ADDENDUM NO. 2

Whiteland Community High School Phase 2A
300 E. Main Street
Whiteland, IN 46184

PROJECT: Whiteland Community High School Phase 2a

DATE OF ADDENDUM: May 2, 2024

SITE LAYOUT PLAN -
PHASE 2A

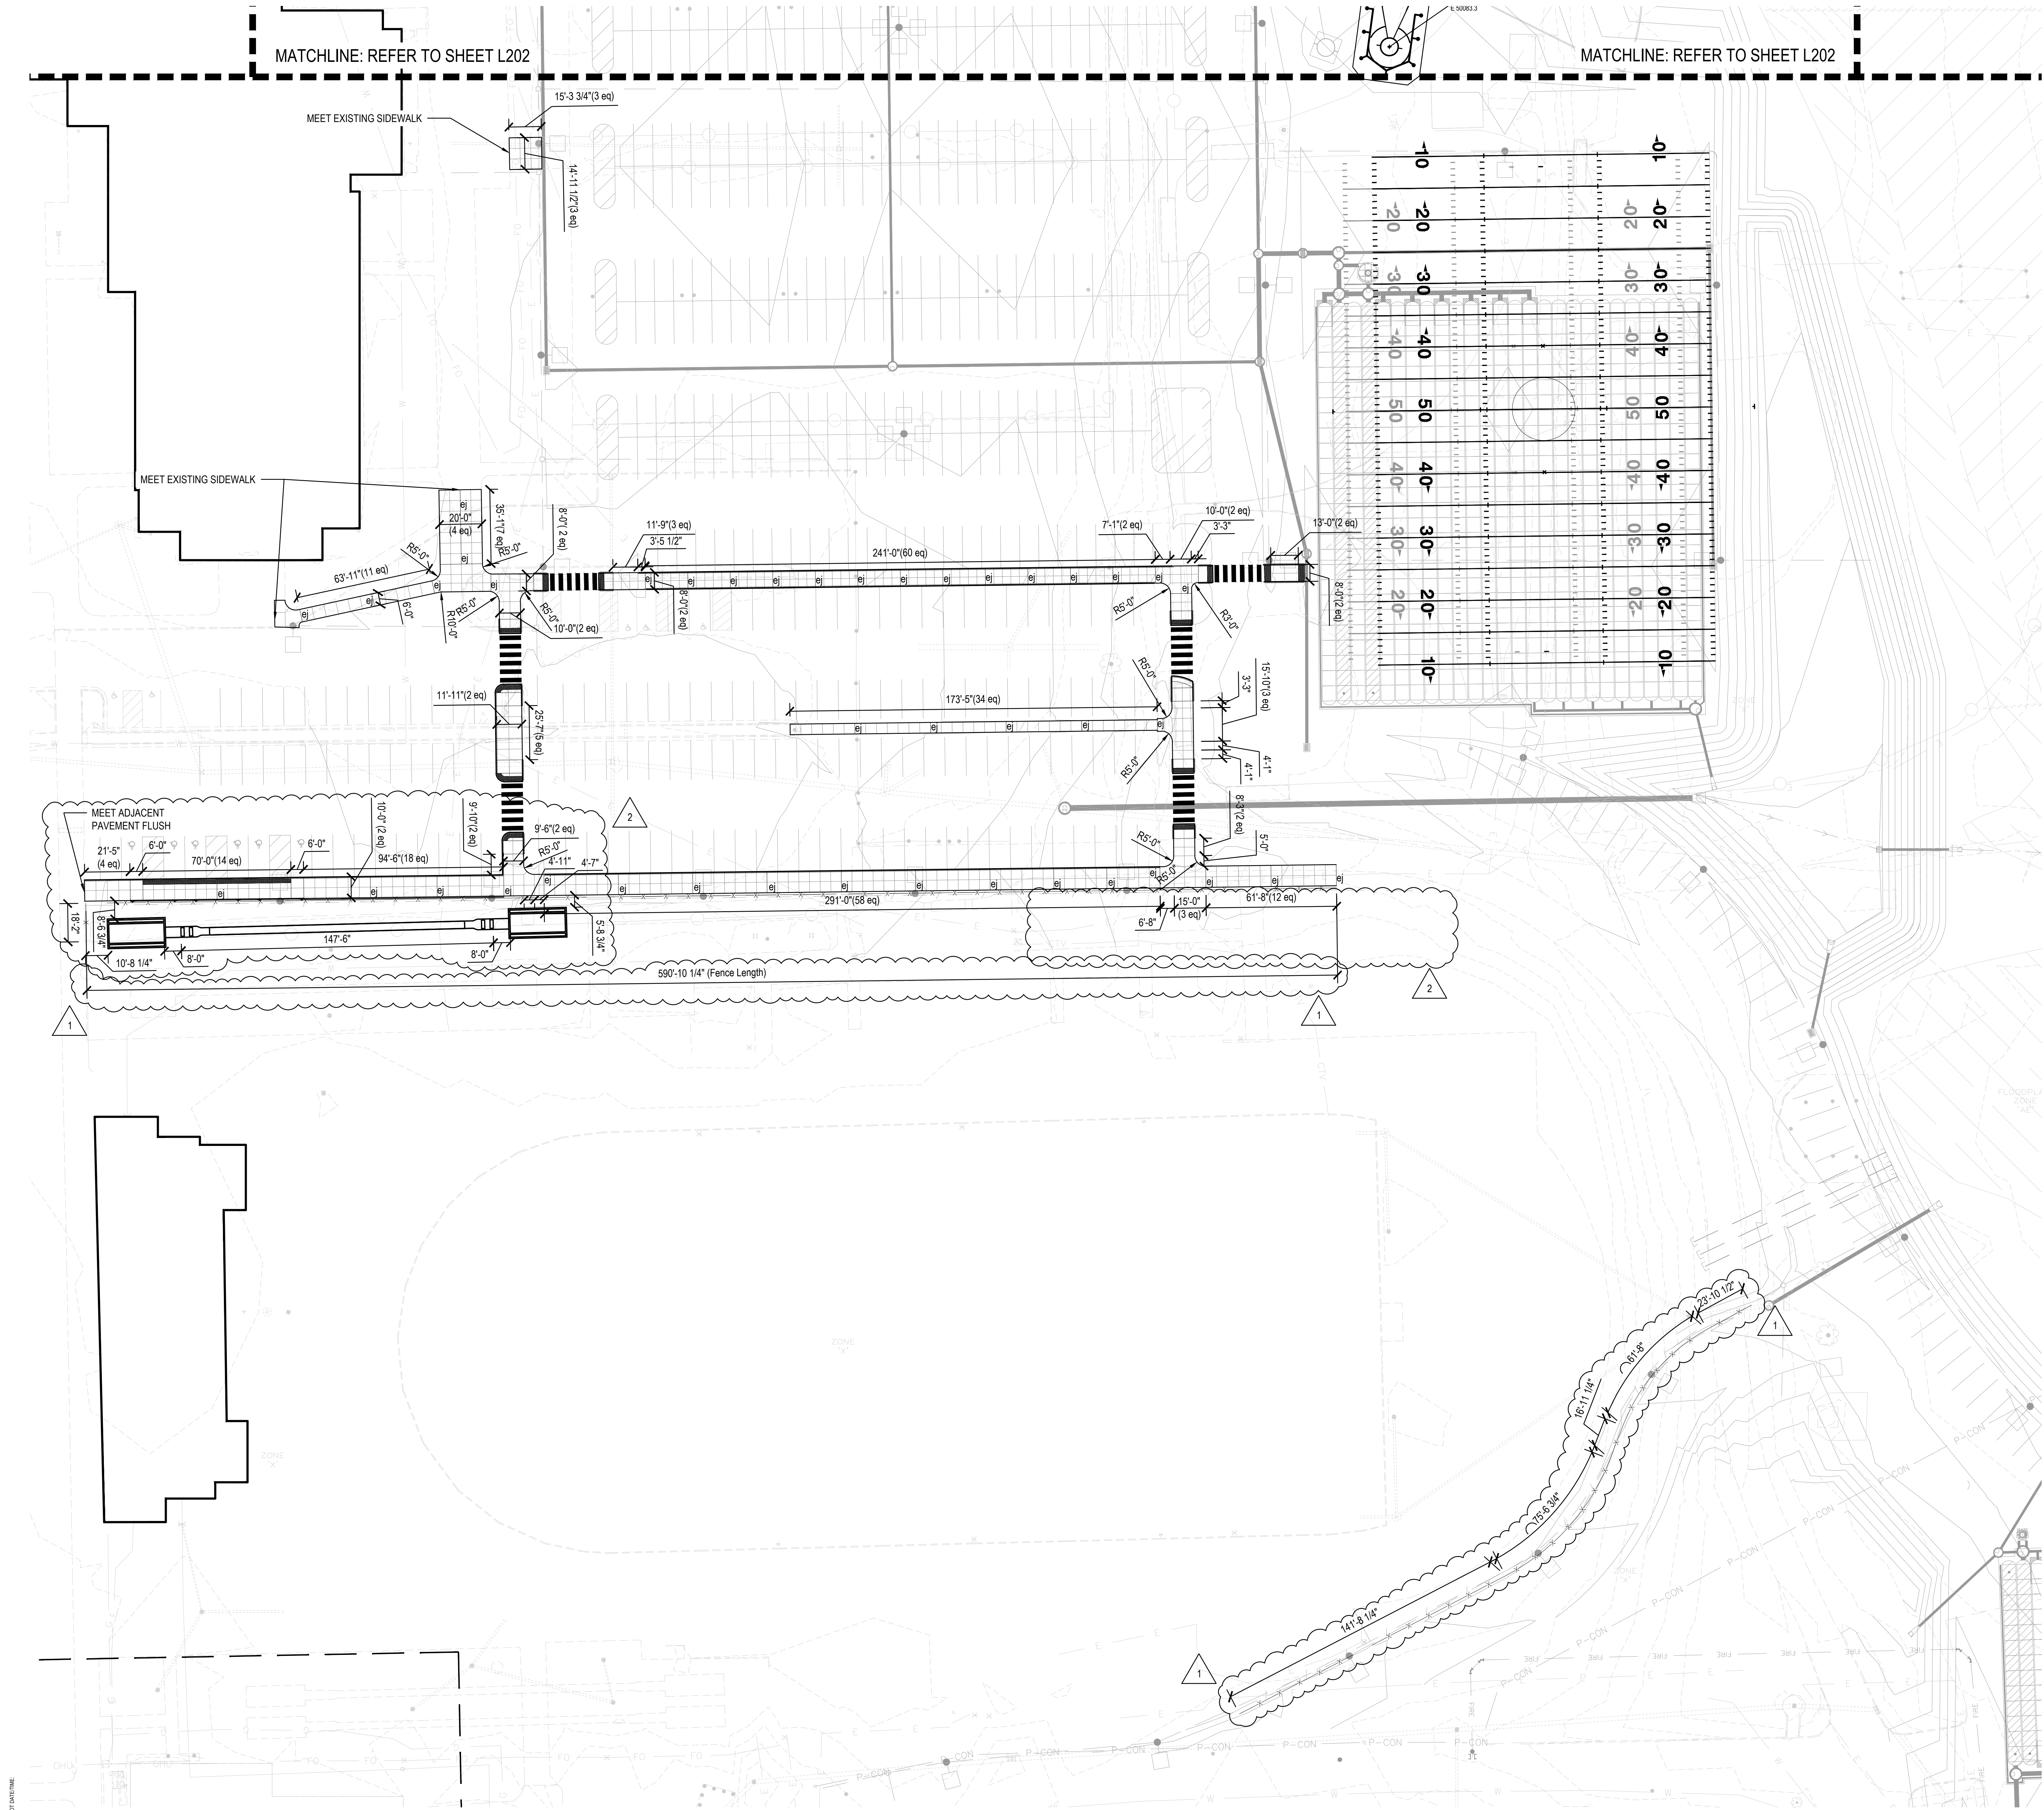
Location of Long Jump revised.
- 22. Drawing Sheet: L201 SITE LAYOUT PLAN – PHASE 2A**

Layout of Long Jump revised.
- 23. Drawing Sheet ES102**

1 ELECTRICAL DEMOLITION SITE PLAN
SCALE: 1" = 50'-0"

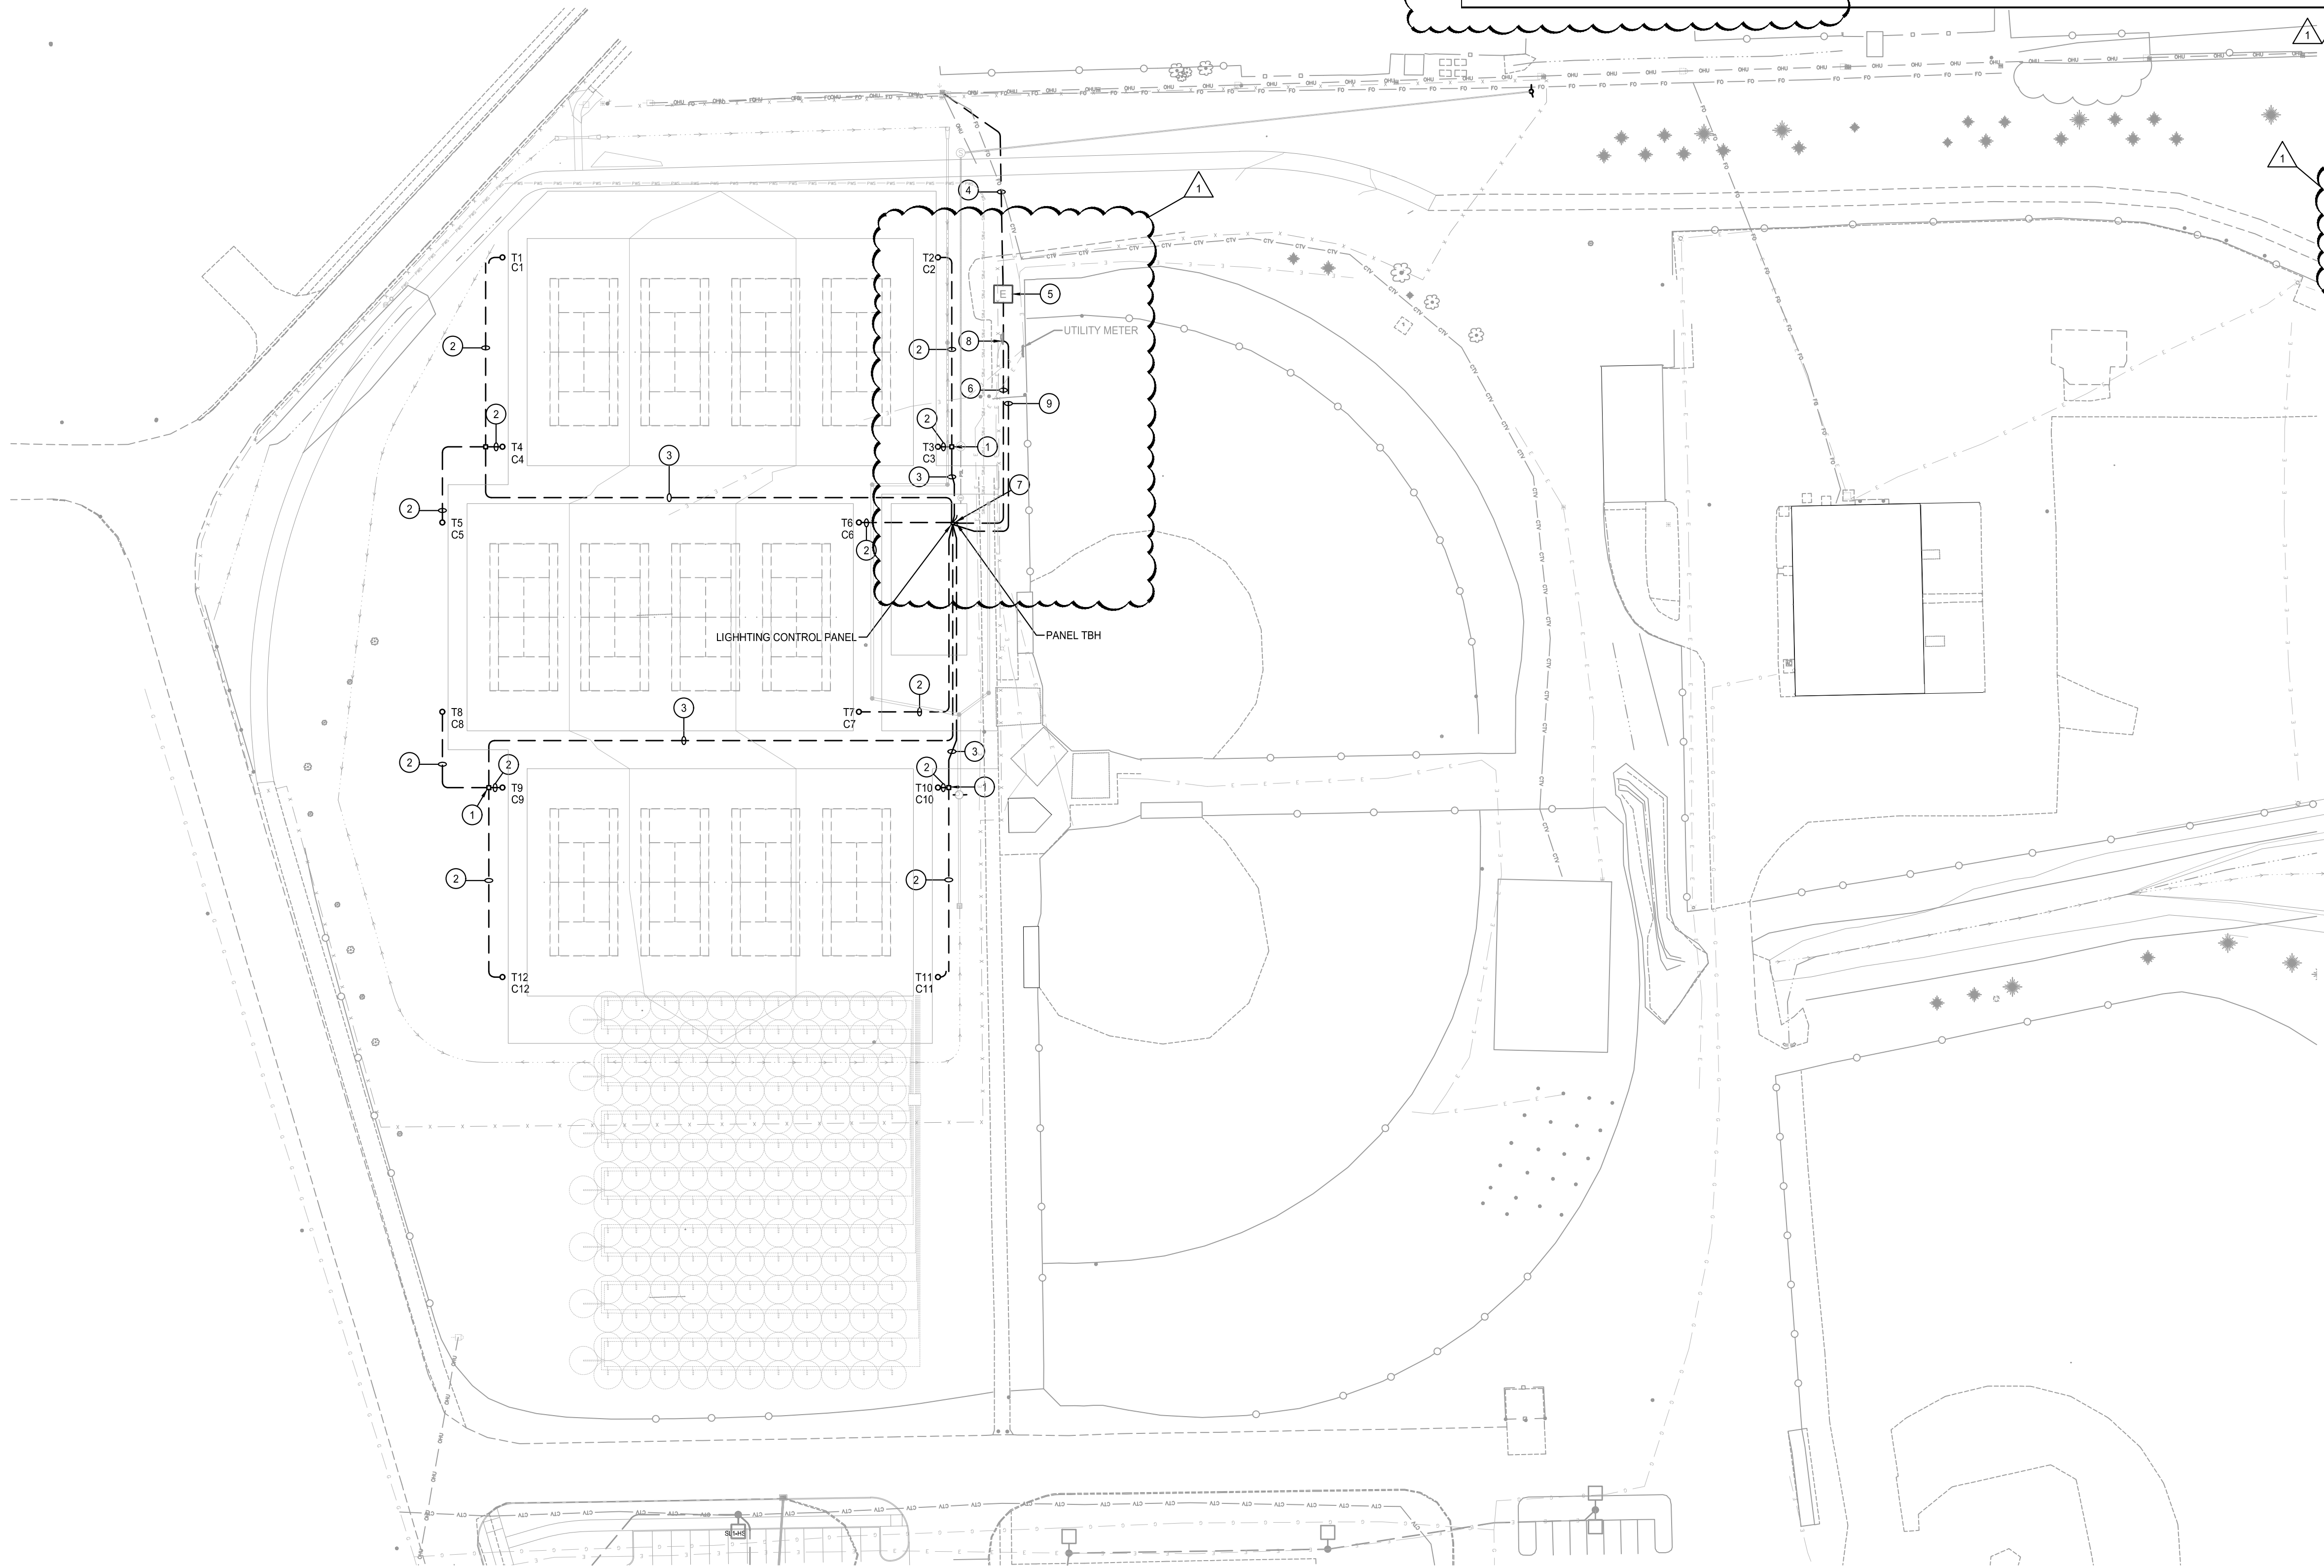
Drawing Sheet Title: Electrical Site Demolition Plan

- a) Drawing #1: Relocation of football field transformer.
 - b) Plan notes: Added additional plan notes.
- 24. Drawing Sheet ES201**

ES201

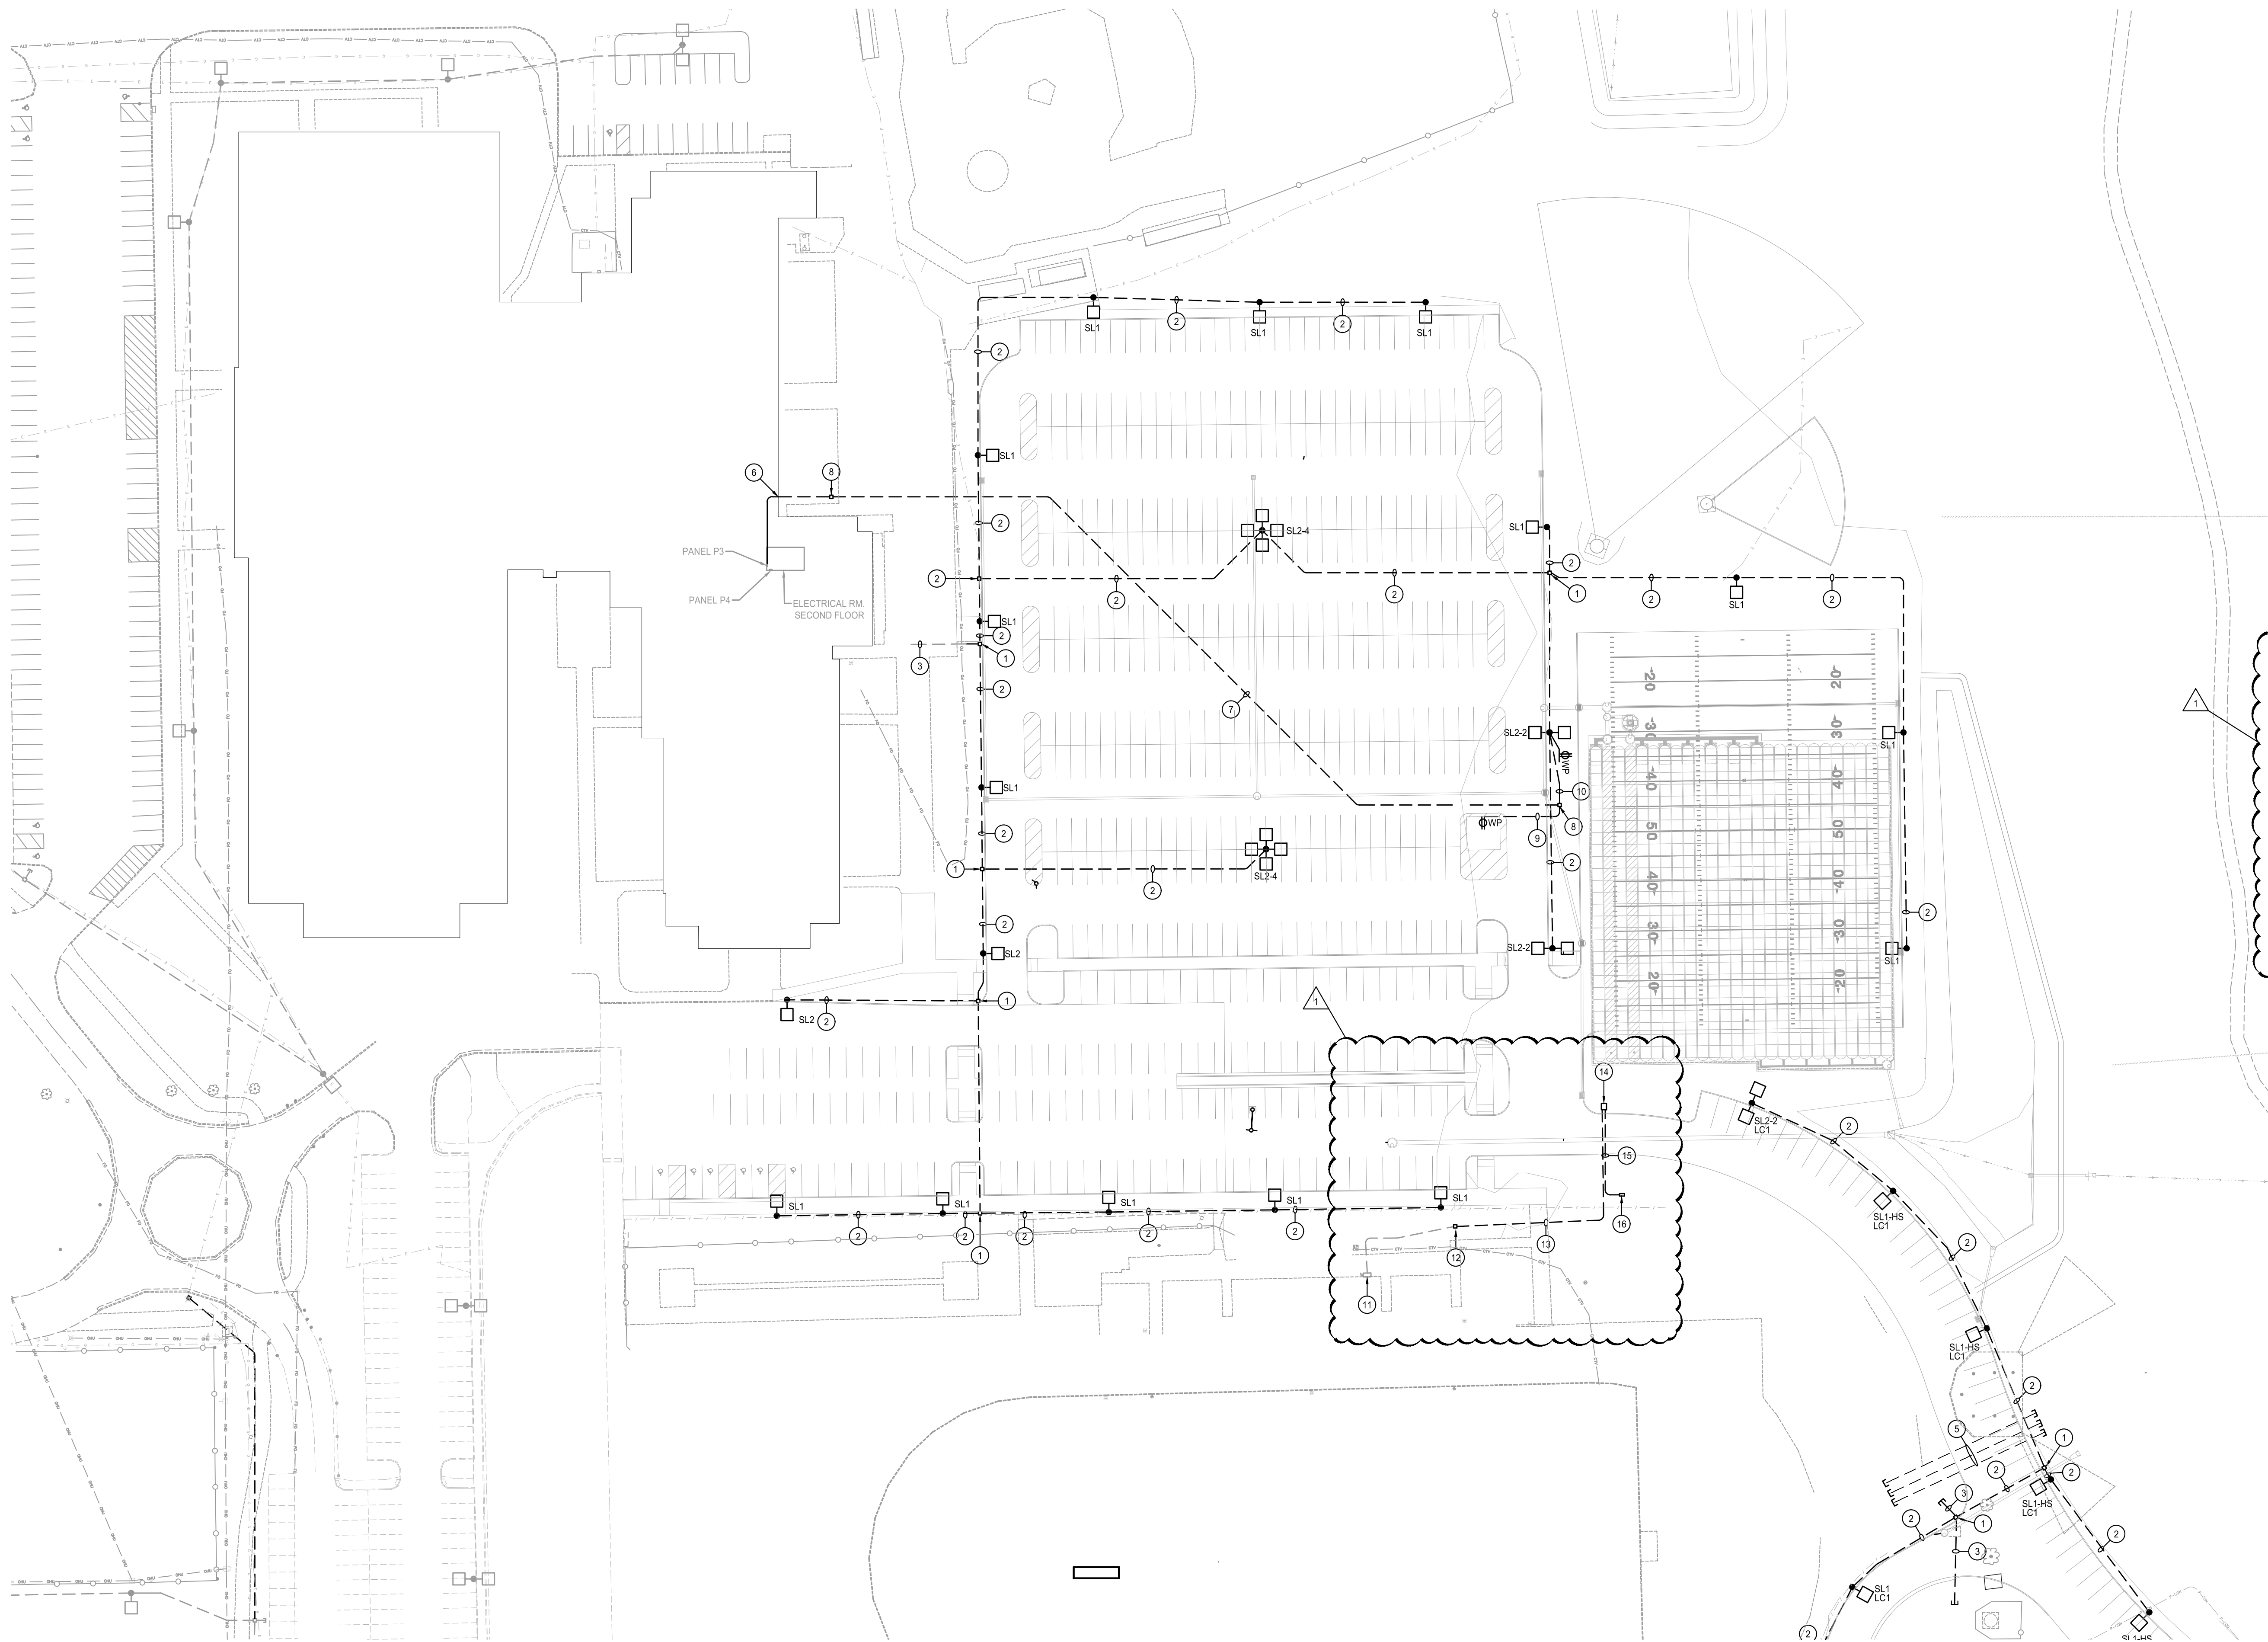
Drawing Sheet Title: Electrical Site Plan

- a) Drawing #1: Noted control circuit to be served from existing panel
 - b) Plan notes: Added additional plan notes.
